# UNITED STATES PATENT AND TRADEMARK OFFICE

APPLICATION NO.	FILING DATE	FIRST NAMED INVENTOR	ATTORNEY DOCKET NO.	CONFIRMATION NO.
10/568,989	02/21/2006	Armin Pieroth	65999-0010	3597
10291 7590 11/15/2007 RADER, FISHMAN & GRAUER PLLC 39533 WOODWARD AVENUE SUITE 140 BLOOMFIELD HILLS, MI 48304-0610			EXAMINER MISA, JOAN D	
			ART UNIT 4155	PAPER NUMBER
			MAIL DATE 11/15/2007	DELIVERY MODE PAPER

<b>Office Action Summary</b>	<b>Application No.</b>	<b>Applicant(s)</b>	
	10/568,989	PIEROTH ET AL.	
	<b>Examiner</b>	<b>Art Unit</b>	
	Joan D. Misa	4155

## DETAILED ACTION

Partially reproduced Figure 30 of WO 01/87047 A1 (View looking down on drum)

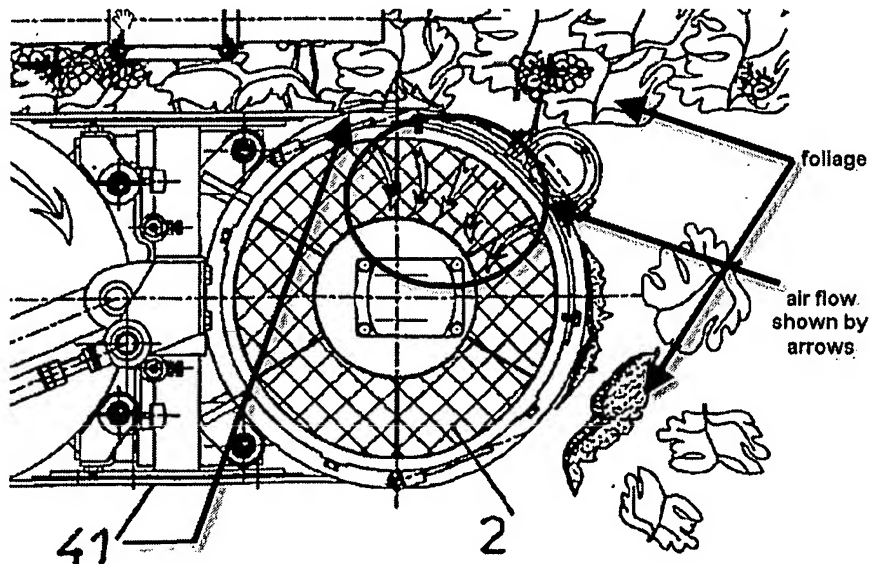
Regarding claim 31, the examiner views a flow channel as the path of airflow caused by the suction device. Pellenc et al discloses the leaf-stripping device of claim 30, "wherein the cover plate (as set forth above in claim 30) is fastened to the flow channel on a side facing the foliage." Referring to Figure 30 below, the airflow is shown passing through track (41) and drum (2) from the side facing the foliage.

Reproduced Figure 2 of FR 2417932 A1.

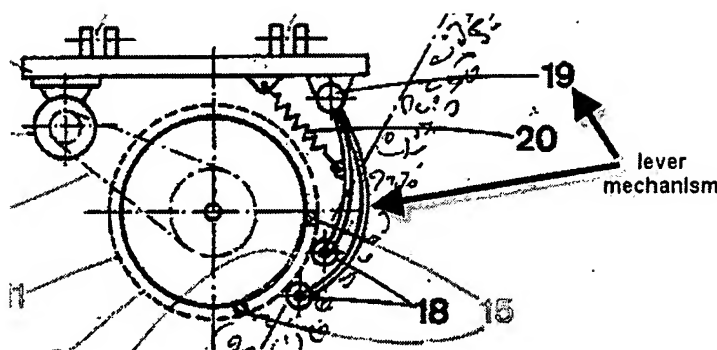
Regarding claim 1, Bou discloses a leaf-stripping device comprising "a suction blower (Fig. 1, 6) and leaf-stripping tools arranged in front of the suction blower, the leaf-stripping tools including two rotatable cylinders (Fig. 2, 11 and 18) arranged substantially parallel to each other, at least one of the rotatable cylinders (11) being coupled to a drive motor (7)."

Regarding claim 23, Bou discloses the leaf-stripping device of claim 1 "wherein one of the cylinders (18) is not coupled to the motor (7) and is spring-loaded (20) against the other of the cylinders (11)"

Regarding claim 24, Bou discloses the leaf-stripping device of claim 23 "wherein the cylinder (18) that is not coupled to the motor is supported in a lever mechanism (shown below) against which pressure springs (20) for the cylinder bear pressure."
